PLANNING DEPARTMENT – Development Review Services

September 30, 2016

**RE: Albuquerque Biopark Zoo Penguin Exhibit
Grading & Drainage Plan
Engineer's Stamp Date 9-15-2016 (File: K13D034G)**

OVERALL
GRADING AND
DRAINAGE PLAN

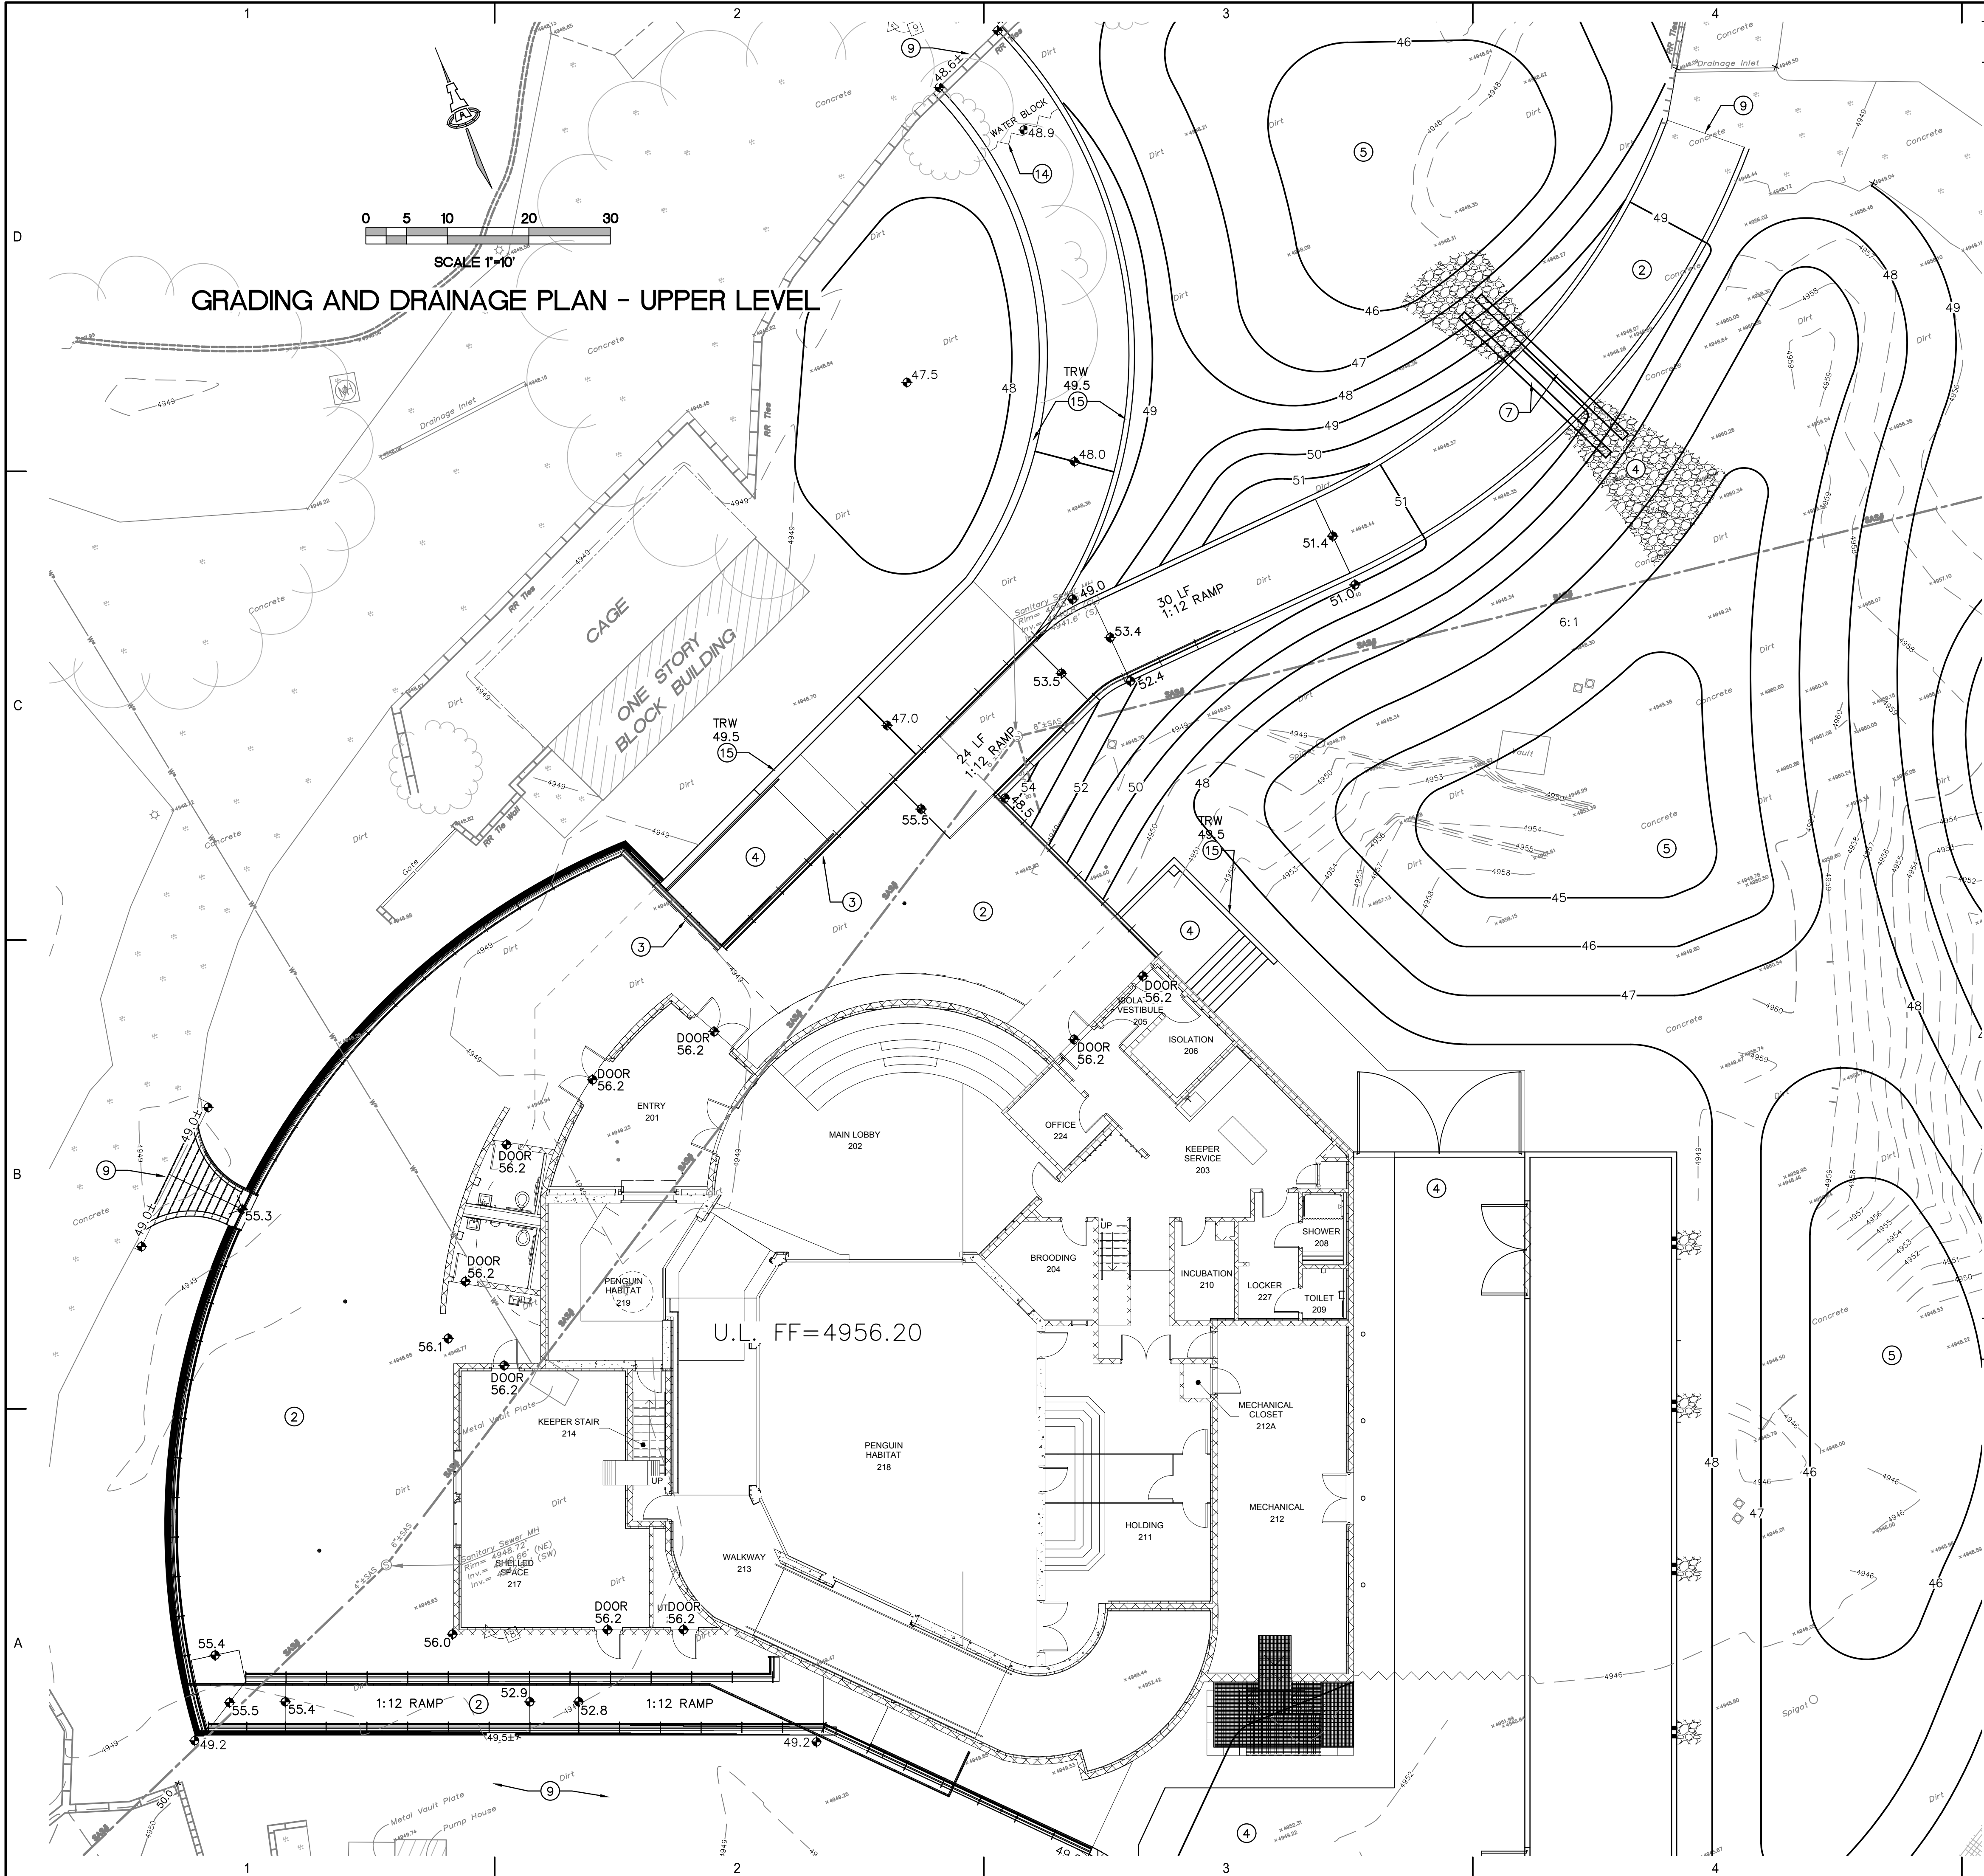
1. Provide an overall plan of the Zoo showing the location of the proposed development, including the pond and park that would accept any overflow of the retention ponds.

2. Provide calculations that show the Max WSE of the retention ponds (use the 10 day storm for permanent retention ponds per DPM). Show the MWSE on the plan.

3. Clarify the location of all retaining walls and note which walls are part of the architectural plan set and which walls are part of the Civil plans. All retaining walls need to show the Top of Wall and Bottom of Wall elevation.

4. Verify that the Zoo is willing to accept drainage discharging over the retaining wall. This seems very unusual since such discharge will stain and erode the wall over time. If this is in fact acceptable, show depressed areas that would collect the flows.

5. Provide a basin map.
6. Contact Jane Rael (505-289-3439) at the WUA to verify that they will in fact accept drainage from the trench drain into the sanitary sewer. If so, ensure that the plumbing sheets show a pipe tied to the trench drain. Provide the Plumbing sheet. (11x17 only)

7. Provide Sections showing how the building relates to the site. Include the open mechanical area in the section.
8. Define the surface materials particularly the area on the east side of the building.

9. Walkway on the south side shows curb using triple lines. What is the meaning? Provide section cut.
10. The narrative states that the previous drainage scheme is being used, but the existing contours do not reflect previous ponding. Please clarify.
